FORM APPROVED
OMB NO. 1004-0135
Expires: July 31, 2010**SUNDRY NOTICES AND REPORTS ON WELLS**
*Do not use this form for proposals to drill or to re-enter an abandoned well. Use form 3160-3 (APD) for such proposals.*5. Lease Serial No.
NMLC061616A

☒ Oil Well ☐ Gas Well ☐ Other8. Well Name and No.
POKER LAKE UNIT 348H2. Name of Operator
BOPCO LPContact: LESLIE G BARNES
E-Mail: lbarnes@basspet.com9. API Well No.
30-015-38669-00-S13a. Address
P O BOX 2760
MIDLAND, TX 797023b. Phone No. (include area code)
Ph: 432-683-227710. Field and Pool, or Exploratory
POKER LAKE
UNKNOWN

BOPCO, L.P. respectfully requests to run a tapered production casing string in order to seal a leak in the previously installed 7", 26#, HCP-110, BTC casing string. This will allow secondary fracture stimulation of the Wolfcamp interval. The new production string will be ran as follows:

**BOPCO, L.P.
Poker Lake Unit #348H**

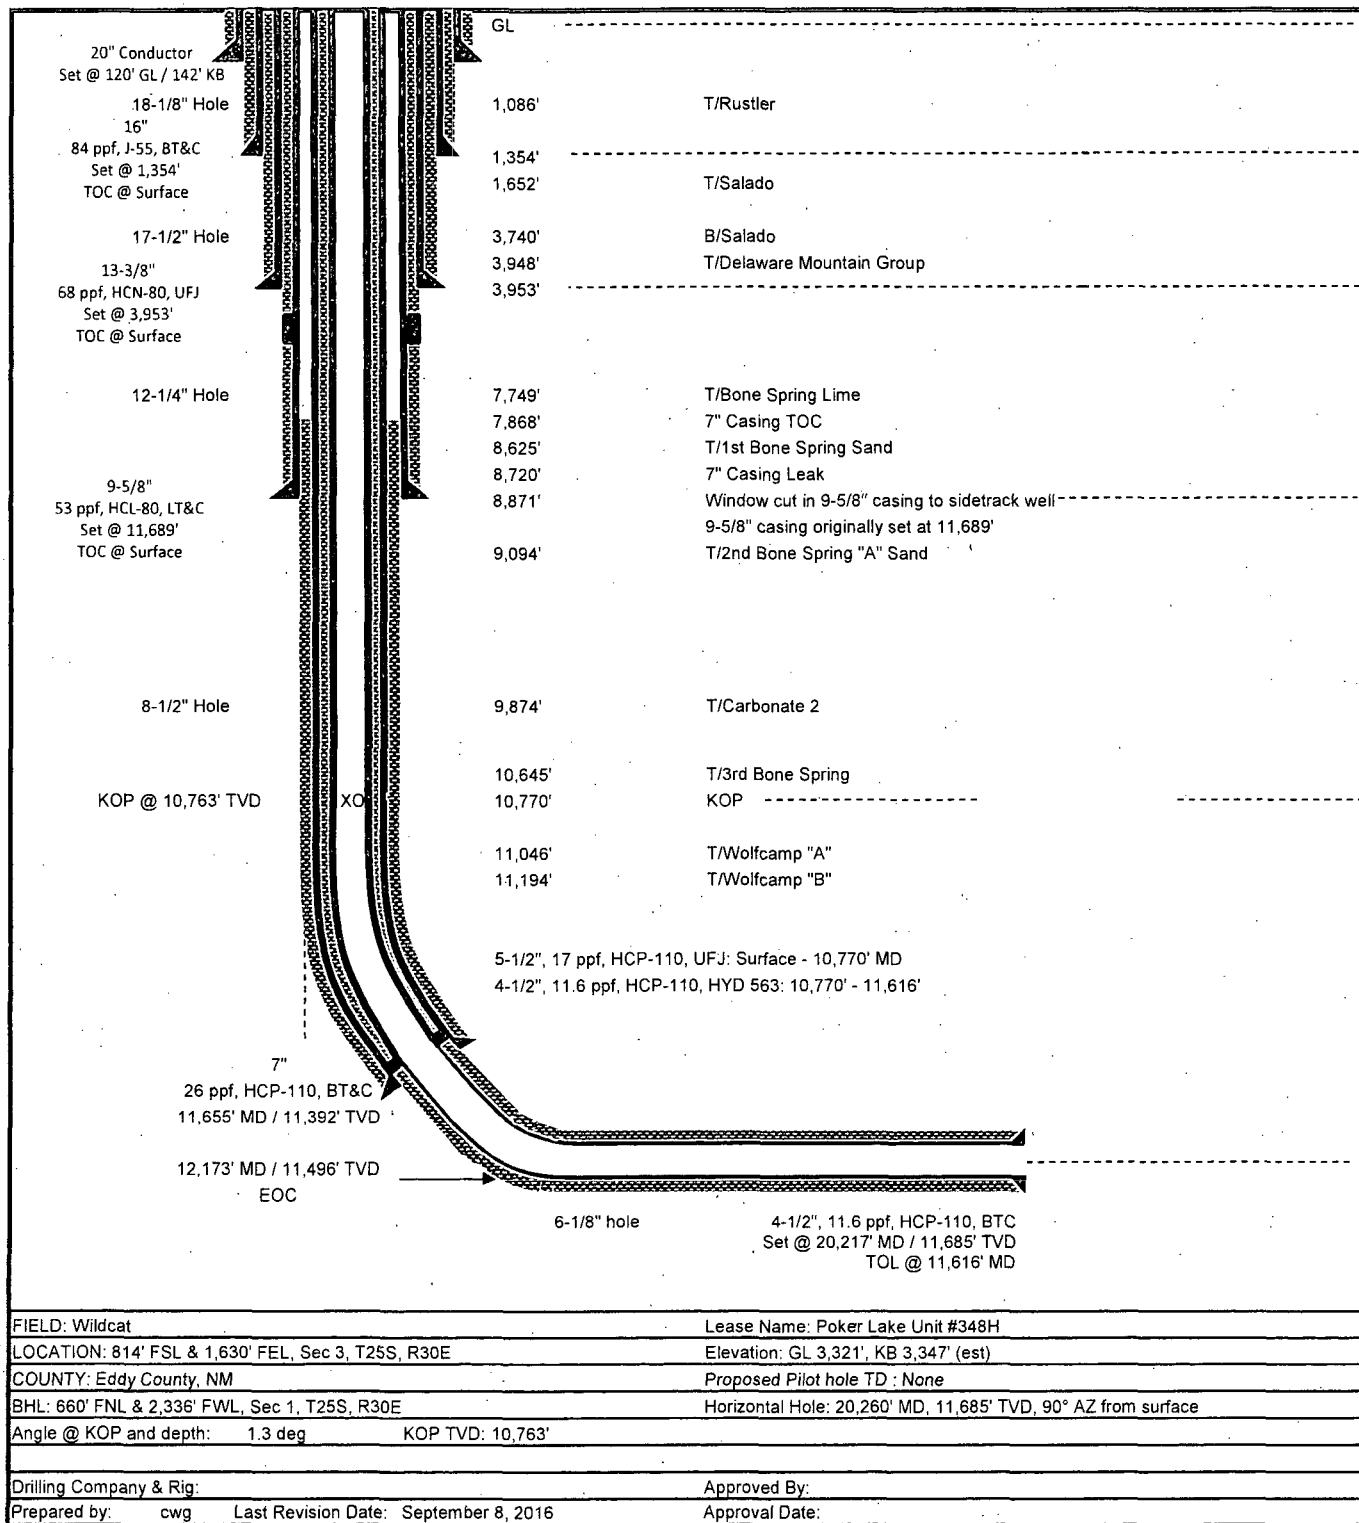
BOPCO, L.P. respectfully requests to run a tapered production casing string in order to seal a leak in the previously installed 7", 26#, HCP-110, BTC casing string. This will allow secondary fracture stimulation of the Wolfcamp interval. The new production string will be ran as follows:

5-1/2", 17#, HCP-110, UFJ from surface to 10,770' MD (10,763' TVD at KOP)

4-1/2", 11.6#, HCP-110, HYD 563 from 10,770' MD (10,736' TVD) to 11,616' MD (11,353' TVD)

The string will be stung into the PBR of the previously installed 4-1/2", 11.6#, HCP-110, BTC liner. The tapered production casing string will be cemented to surface as follows:

Lead: Surface - 7,720' - 11.9 ppg, 2.47 ft³/sk, 13.848 gal/sk of 50:50 Poz + 5% Salt + 10% Bentonite + 0.2% Retarder *200 SK*

Tail: 7,720' - 11,616' - 12.6 ppg, 1.62 ft³/sk, 8.621 gal/sk of Pecos Valley Light + 1.3% Salt + 5% Expander + 0.1% Retarder *200 SK*

BOPCO, L.P. requests a variance to the 0.422" cement sheath for this casing string. According to Onshore Order #2, III. B., "The proposed casing and cementing programs shall be conducted as approved to protect and/or isolate all usable water zones, lost circulation zones, abnormally pressured zones, and any prospectively valuable deposits of minerals." Note that the subject well has already been drilled and completed (4 stages) per the approved APD issued on 03/11/2011 as well as the sundry to re-enter and sidetrack this well which was approved on 09/08/2014. As such, the conditions of the Onshore Order #2, III. B. have already been met.

During initial completion, a leak developed within the production casing string and the leak was remedied by a cement squeeze that was tested to 3,000 psi before the well was placed on production. BOPCO, L.P. believes that the addition of another casing string does not constitute a qualification of the guidelines set forth in Onshore Order #2 for the purpose of meeting condition III.B. The proposed additional casing string will be used in order to ensure that wellbore integrity is maintained during secondary fracture stimulation of the Wolfcamp interval. The cement sheath on the proposed casing string would be 34 hundredths of an inch less than is typically required but in our view, would pose no undue risk since the Onshore Order conditions have already been met. As such, we are requesting a variance to the 0.422" cement sheath requirement to run the proposed 5-1/2", 17#, HCP-110, UFJ x 4-1/2", 11.6#, HCP-110, HYD 563 production casing string.

*Notify BLM if cement
does not circulate.*
